The Town of Erie

Memo

To: Matt Janke and Chris Elliott, MR Erie, LLC
From: Hannah Hippely
Date: January 25, 2019
Re: SK-000978-2018 – Spring Hill Sketch Plan Application
cc: Deborah Bachelder

Comprehensive Plan Map

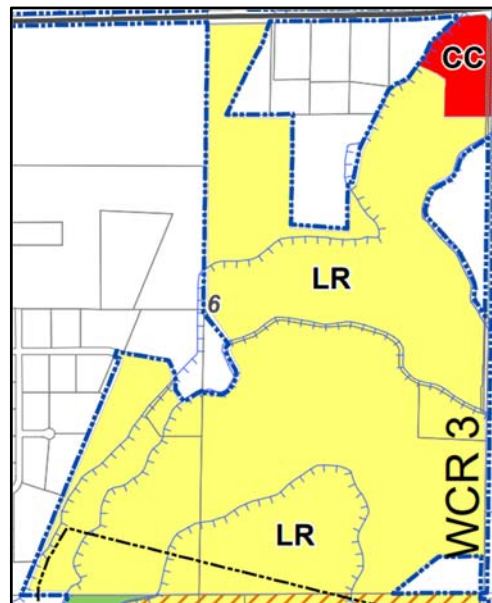
- a. All of the uses proposed by the sketch plan are permitted within the LR Zone District and the zoning allows for all of the land use designations of the Comprehensive Plan.
- b. The proposed sketch plan is not consistent with the Comprehensive Plan Agriculture (AG) land use designation for this property.
 - i. Approximately 70 acres in the south portion of the property is designated as Agriculture (AG) on the Comprehensive Plan. According to the Comprehensive Plan farming, ranching, and other agriculturally related uses and very low density rural residential uses

- are appropriate in this area. Also, lands designated Agriculture “serve a vital role in defining the history and character of Erie and should be maintained where viable, to serve as gateways and buffers, preserve vistas, and retain the desired character of the Town.” Within this area the plan shows the western edge, the areas adjacent to the western two ditches (Lower Boulder Ditch and the Boulder/Weld Ditch), as open space and develops the remainder at a density consistent with an LDR land use designation.

- ii. The LR Zone Designation does not negate the need for the subdivision to be consistent with the Comprehensive Plan. A Comprehensive Plan land use map change would need to be approved if the subdivision is not redesigned to be consistent with the Comprehensive Plan.

- c. It appears that over all residential densities comply with the Comprehensive Plan and Zoning Map.
 - i. Tract Q, which is located along the western edge of the development adjacent to the rural Weld County subdivision and the south east corner of the property are two areas designated RR on the Comprehensive Plan where residential densities of 0-2 dwelling units per acre (du/ac) and gross density not to exceed 1 du/ac is expected.

1. The south east corner the proposal includes a school site in addition to residential development within the roughly 30 acres shown as RR.
 2. No development is proposed in Tract Q.

- ii. The area designated as LDR on the Comprehensive Plan within the subject property is approximately 160 acres. LDR densities are expected to be 2-6 du/ac with gross densities not to exceed 4 du/ac or 640 dwellings.

- iii. The proposal includes 632 lots which is in line with the overall densities expected by the Comprehensive Plan for the developed portions of the property. At the time of preliminary plat this analysis shall be presented by the applicant to demonstrate compliance with the Comprehensive Plan density expectations as shown on the land use map.

- d. The Comprehensive Plan and the Zoning Map show a flight cone associated with the Parkland Airport over southern portions of the property. The applicant will need to coordinate with the Parkland HOA as part of the preliminary plat process.

- e. As shown on the Comprehensive Plan, the sketch plan includes a school site in the south east portion of the site.

Zoning Map

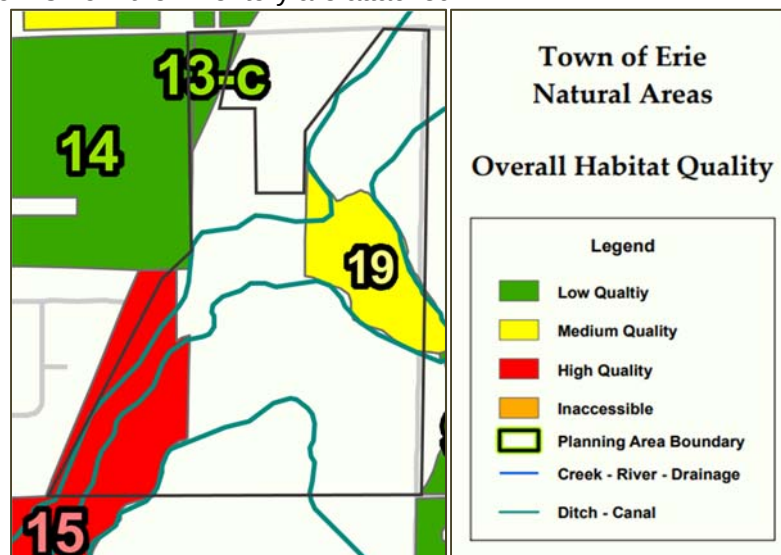
- iv. LR Zoning allows for a gross density not to exceed 5 du/ac. Gross density is the total number of dwelling units allowed based on the size and zoning designation but not taking into account the portions of unbuildable land. At the time of preliminary plat this analysis shall be presented by the applicant to demonstrate compliance with the zone district density expectations however, at this time staff estimates the allowed maximum density to be 780 units.
